# ADDENDUM #1 TO MONTANA DEPARTMENT OF TRANSPORTATION INVITATION FOR BID #HWY-309446-RP

The purpose of this addendum is for the evaluation results for the Approved Equivalent requests on the 17, 20 & 21- Passenger Gas Cutaway Buses per the attached forms.
All other terms, conditions, specifications and incidentals shall remain the same as originally stated in Invitation for Bid #HWY-309446-RP
ADDENDUM ACKNOWLEDGEMENT:
(Vendor Signature)
(Date)
hereby acknowledge that I have received a copy of Addendum #1.
A copy of this signed addendum <b>MUST</b> be included with your bid response. Failure to include a copy of this addendum with your response will result in disqualification of your response.
MDT attempts to provide accommodations for any known disability that may interfere with a person participating in any service, program or activity of the Department. Alternative accessible formats of this information will be provided upon request. For further information call Richele Parkhurst at (406) 657-0274 Voice or 1-800-335-7592 TTY or TTY (406) 444-7696.

REQUEST FOR EXCEPTIONS/APPROVED EQUALS FORM

TITLE OF DOCUMENT REFERENCE: Fergus County Floor Plan Request

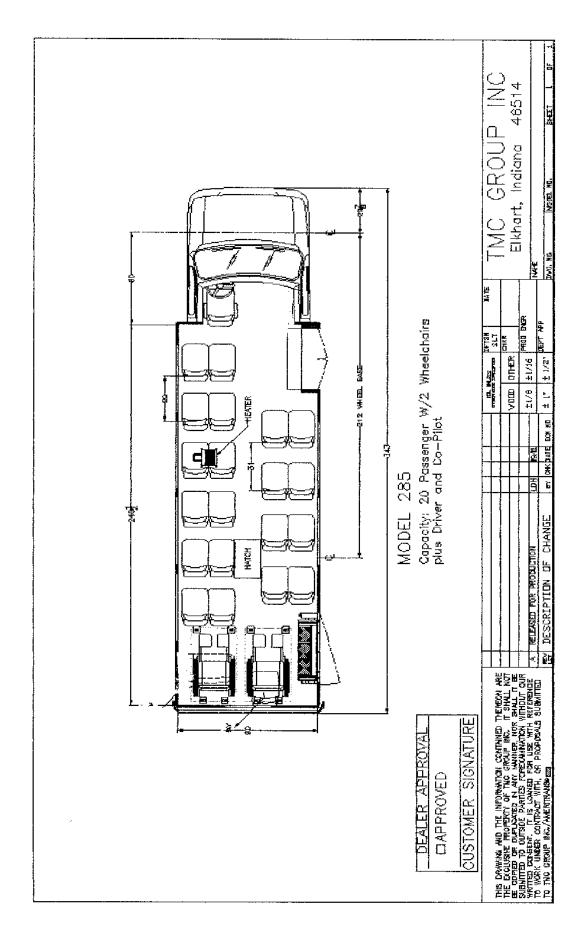
Due to the 20 passenger seating we are required to increase the wheel base to a 212" wheel base. As you can see by the floor plan there is a copilot door/area where the 2 required storage compartments would be located. This is done to allow the A/C evaporator/heater to be located above the driver blowing towards the passengers faces for more efficient cooling as well as heating. This innovative change also placed more of the weight forward in the bus to allow this bus to meet GVWR weights and to alleviate the rear head room issues. This design will also place the double out entry doors as shown behind the co-pilot door. This vehicle can also accommodate a 2 passenger fold away seat at the rear if desired!

Please approve these changes to the floor plan specified in Fergus County's bid. We appreciate your attention to this matter and please contact me if further information is needed.

The 20 passenger with 2 w/c vehicle is not a traditional style vehicle procured by the MDT and the floor plan requirements appear to exceed the tolerable chassis specifications.

After reviewing Mr. Walle's exceptions to the 20 passenger w/ 2 w/c vehicle specifications, MDT has determined that the suggested vehicle chassis, as specified in HWY#309446, will have <u>insufficient</u> weight distribution, if a rear frame extension is accepted and a center frame extension dismissed. After close review, MDT has determined that a center frame extension is necessary, possibly in conjunction with a rear frame extension, for proper weight distribution. Mr. Walle's suggested chassis and floor plan are suitable alternatives to that specified for the 20 passenger w/ 2 w/c.

Mr. Walle has asked to allow the A/C evaporator/ heater to be located over the driver's area to better balance chassis weight. MDT will accept this change only if a rear auxiliary heating / cooling unit is installed with a total vehicle cooling / heating capacity that meets or exceeds that stated in the specifications. The required 2 storage compartments above the driver's area may be relocated as long as the compartments do not obstruct passenger movements.

- Acceptable: 176-190" wheelbase with a Ford QVM certified or equal chassis manufacturer's certification, center frame extension.
- Acceptable: TMC Group Inc., Model 285 floor plan
- Acceptable: Front A/C evaporator/heater granted that a rear auxiliary heating / cooling unit is
  installed with the total vehicle cooling / heating capacity meeting or exceeding that stated in the
  specifications
- Acceptable Relocation of the 2 driver's area storage compartments

TITLE OF DOCUMENT REFERENCE: Fergus County Floor Plan Request

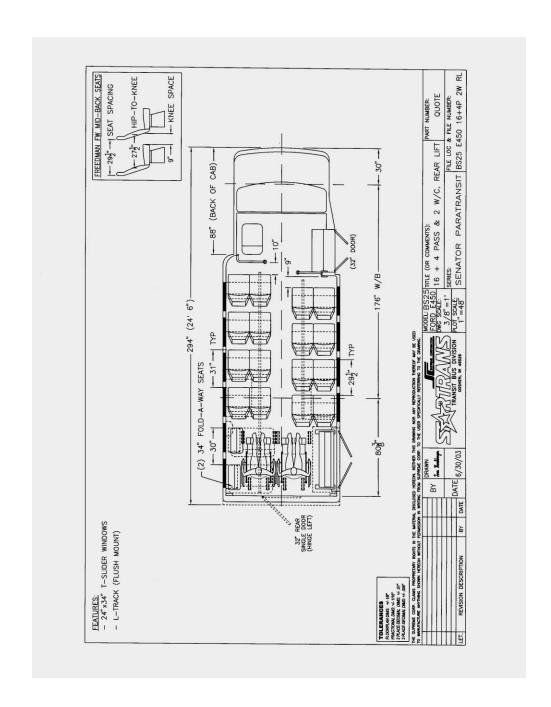
To accept this floor plan

The 20 passenger with 2 w/c vehicle is not a traditional style vehicle procured by the MDT and the floor plan requirements appear to exceed the tolerable chassis specifications.

Mr. Spore's floor plan configuration is acceptable under these conditions:

- Vehicles must include two (2), two-passenger (double) Freedman BV Fold-A-Way Series with padded grab rails or approved equal
- Foldaway seats shall be covered in Repel, Level 6 fabric or approved equal
- Seat color the same as the stationary seats
- All foldaway seats must have either padded grab rails or a durable nylon plastic handle
- Fold away seat belts shall be USR (Under Seat Retractor)
